Agenda Item # 4

SUB-003450-2025

Evergreen Gardens Subdivision, Resubdivision of Lot 190

APPLICATION NUMBER 4 DATE October 16, 2025

DETAIL SITE PLAN

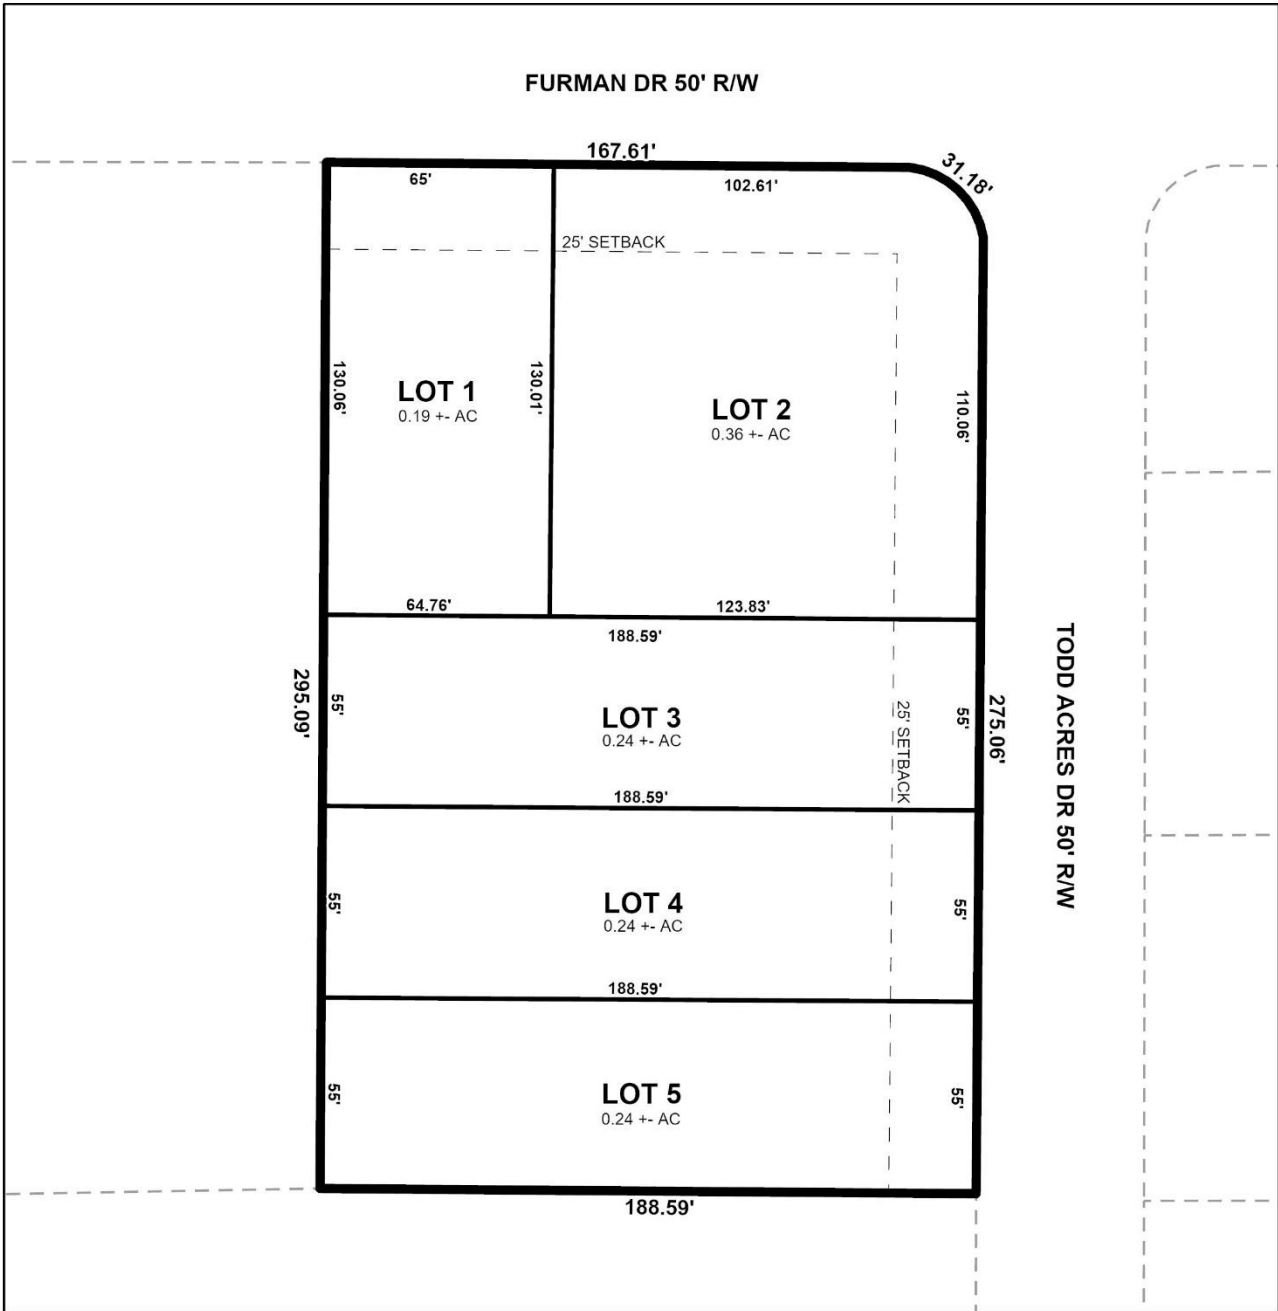
The proposed lots will have frontage along Furman Drive, with Lot 2 also having frontage along Todd Acres Drive. Both streets are classified as minor streets without curb and gutter, each requiring a 60-foot-wide right-of-way. The plat currently depicts 50-foot-wide rights-of-way along both streets. Therefore, if approved, the plat should be revised to depict dedication sufficient to provide 30 feet from the centerline of each street, unless the Planning Commission approves a waiver of Section 6.C.9. of the Subdivision Regulations.

A sufficient radius is depicted at the intersection of Todd Acres Drive and Furman Drive, consistent with Sections 6.B.12. and 6.C.6. of the Subdivision Regulations. This information should be retained on the Final Plat, if approved.

Proposed Lots 1 and 2 meet the minimum width requirement of Section 6.C.2.(b)(2) of the Subdivision Regulations for residential lots within the Suburban Sub-District (60 feet). However, proposed Lots 3, 4, and 5 do not meet this requirement. While narrower than typical lots in the surrounding neighborhood, each of these lots nevertheless meets the minimum area requirements for standard lots. If approved, a waiver of Section 6.C.2.(b)(2) of the Subdivision Regulations will be required.

A 25-foot front yard setback is illustrated along each street frontage, in compliance with Article 2, Section 64-2-5.E. of the UDC and Section 6.C.8. of the Subdivision Regulations. This information should be retained on the Final Plat, if approved, adjusted as necessary for any required dedication.

1. Revision of the Final Plat to depict dedication sufficient to provide 30 feet from the centerline of Todd Acres Drive and Furman Drive, unless a waiver of Section 6.C.9. of the Subdivision Regulations is approved by the Planning Commission;

2. Retention of the 25-foot corner radius at the intersection of Todd Acres Drive and Furman Drive on the Final Plat, in compliance with Sections 6.B.12. and 6.C.6. of the Subdivision Regulations;

3. Retention of the lot sizes in both square feet and acres, or the provision of a table on the Final Plat providing the same information, adjusted for any required dedication;

4. Retention of the 25-foot front yard setback along Todd Acres Drive and Furman Drive on the Final Plat, in compliance with Article 2, Section 64-2-5.E. of the UDC and Section 6.C.8. of the Subdivision Regulations adjusted for any required dedication;
